RESOLUTION MSC.222(82)

ADOPTION OF AMENDMENTS TO THE INTERNATIONAL CODE OF SAFETY FOR HIGH-SPEED CRAFT, 2000

**AMENDMENTS TO THE INTERNATIONAL CODE OF SAFETY
FOR HIGH-SPEED CRAFT, 2000**

Figure 2.6.7a

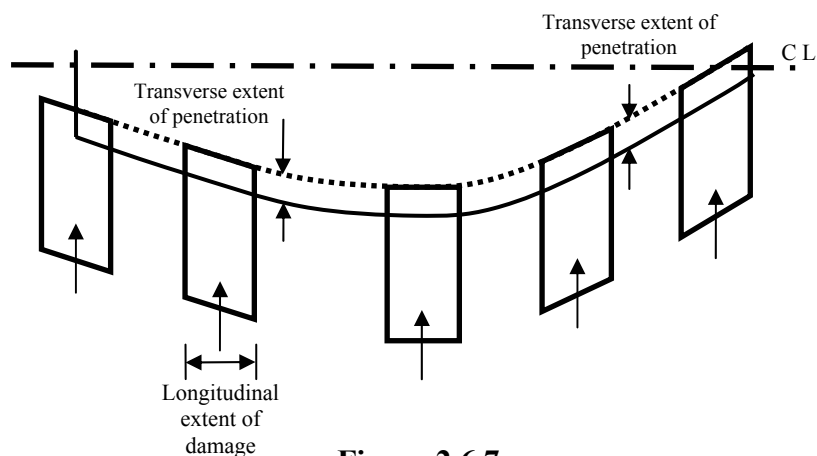
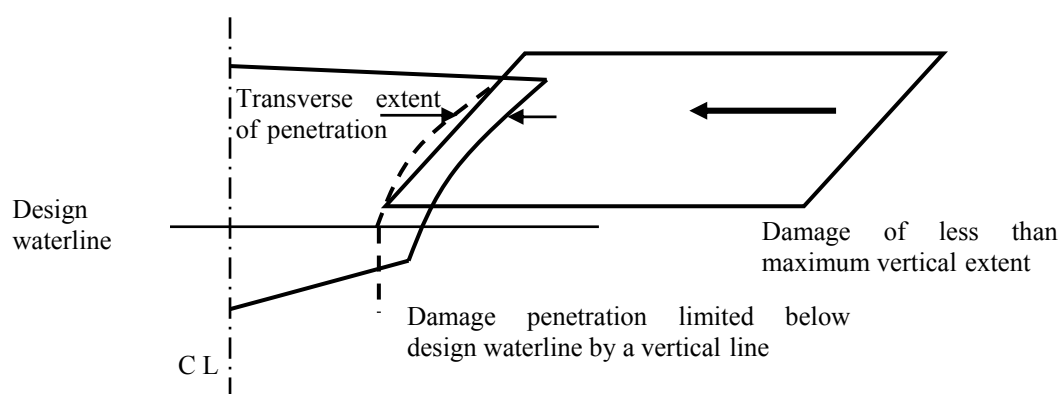
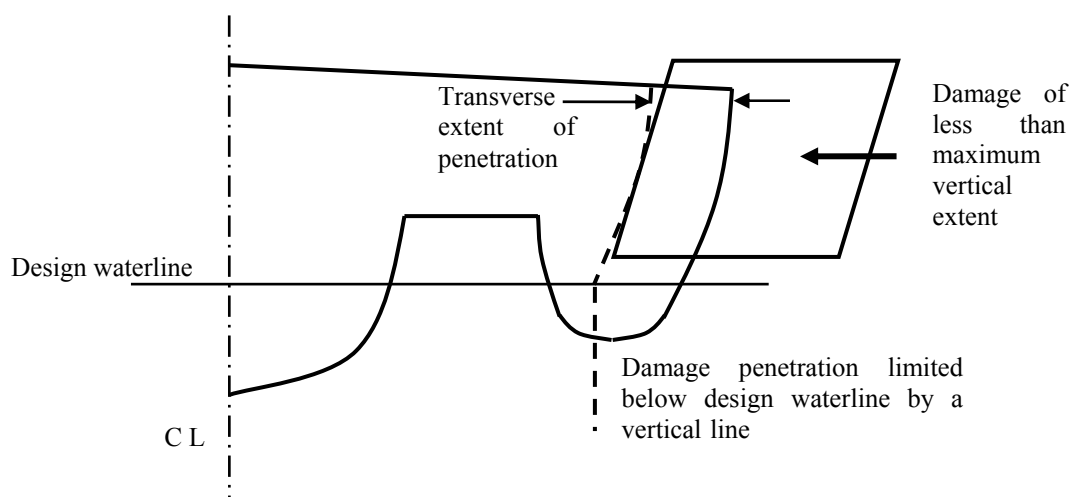
24 The following new section of text is added in continuation of paragraph 2.6.7 after subparagraph 2.6.7.3:

“The damages described in this paragraph shall be assumed to have the shape of a parallelepiped.* Applying this to figure 2.6.7 a, the inboard face at its mid-length shall be tangential to, or otherwise touching in at least 2 places, the surface corresponding to the specified transverse extent of penetration, as illustrated in figure 2.6.7 a.

Side damage shall not transversely penetrate a greater distance than the extent of $0.2\nabla^{1/3}$ at the design waterline, except where a lesser extent is provided for in 2.6.7.2. Refer to figures 2.6.7b and c.

If considering a multihull, the periphery of the craft is considered to only be the surface of the shell encompassed by the outboard surface of the outermost hull at any given section.

Figure 2.6.8”

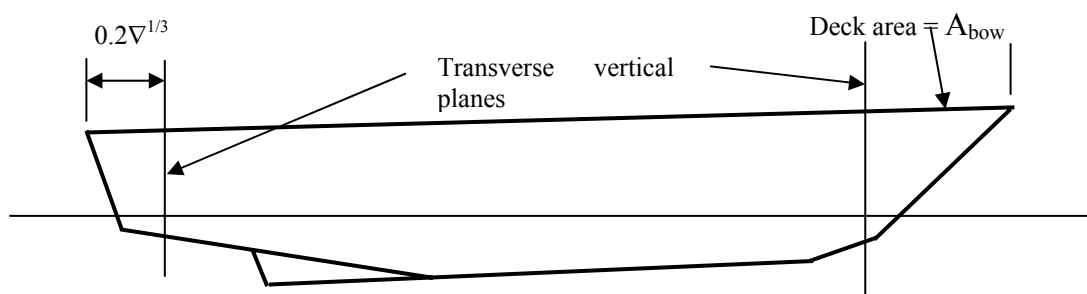
26 Existing paragraphs 2.6.8 to 2.6.12 are renumbered as paragraphs 2.6.9 to 2.6.13 and the following new paragraph 2.6.8 is inserted after the existing paragraph 2.6.7:

“2.6.8 Extent of bow and stern damage

2.6.8.1 The following extents of damage are to be applied to bow and stern, as illustrated in figure 2.6.8:

- .1 at the fore end, damage to the area defined as A_{bow} in 4.4.1, the aft limit of which being a transverse vertical plane, provided that this area need not extend further aft from the forward extremity of the craft's watertight envelope than the distance defined in 2.6.7.1; and
- .2 at the aft end, damage to the area aft of a transverse vertical plane at a distance $0.2\nabla^{1/3}$ forward of the aft extremity of the watertight envelope of the hull.

Figure 2.6.9.2"

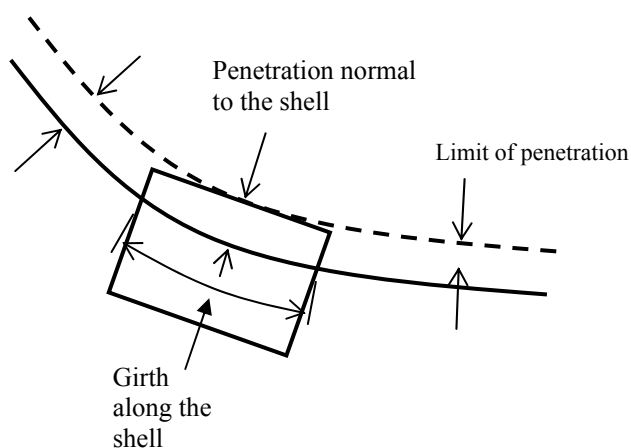
29 The following new paragraph 2.6.9.2.3 is inserted after the existing paragraph 2.6.9.2.2:

“2.6.9.2.3 The shape of damage shall be assumed to be rectangular in the transverse plane as illustrated in figure 2.6.9.2 below. Damage is to be assumed at a series of sections within the defined longitudinal extent in accordance with figure 2.6.9.2, the mid-point of the damaged girth being maintained at a constant distance from the centreline throughout that longitudinal extent.

“.4 the shape of damage shall be assumed to be rectangular in the plane of the shell of the craft, and rectangular in the transverse plane as illustrated in figure 2.6.9.2.”

Figure 7.3.4a

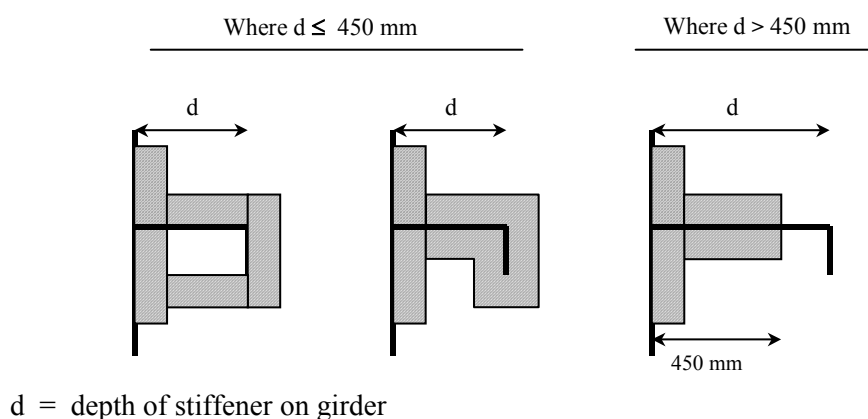
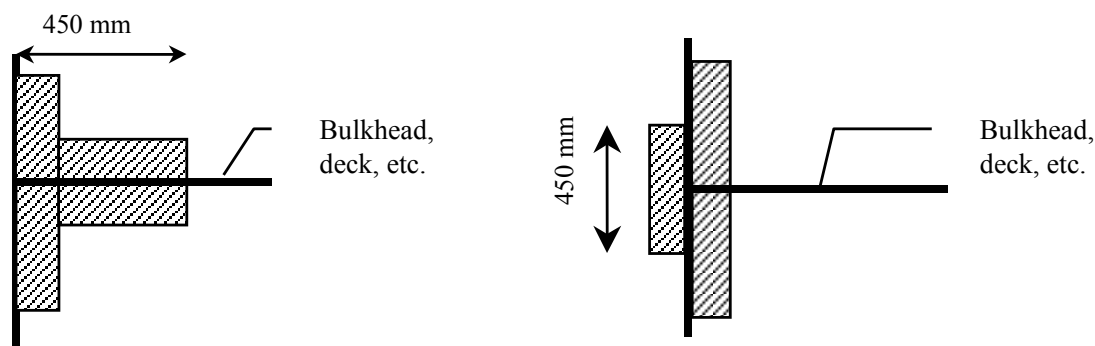
55 The following new paragraphs 7.3.4 to 7.3.6 and associated figures 7.3.4a, 7.3.4b and 7.3.6 are inserted after the existing paragraph 7.3.3:

“7.3.4 To prevent heat transmission at intersections and terminal points, the insulation of the deck or bulkhead shall be carried past the intersection or terminal point for a distance of at least 450 mm in the case of steel or aluminium structures (refer to figures 7.3.4a and 7.3.4b).

Figure 7.3.6

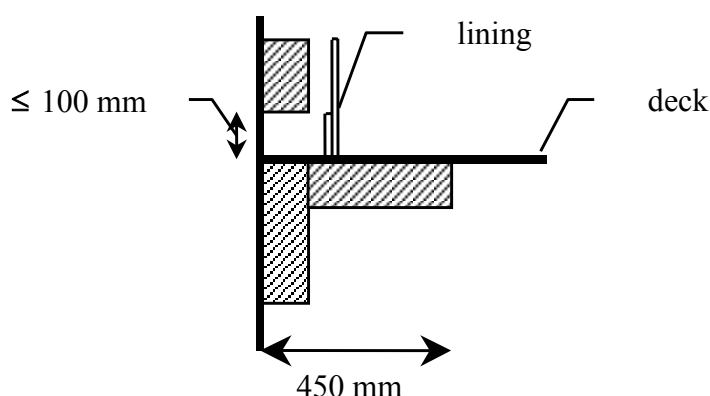
7.3.6 Where the lower part of the fire insulation has to be cut for drainage, the construction shall be in accordance with the structural details shown in figure 7.3.6.”
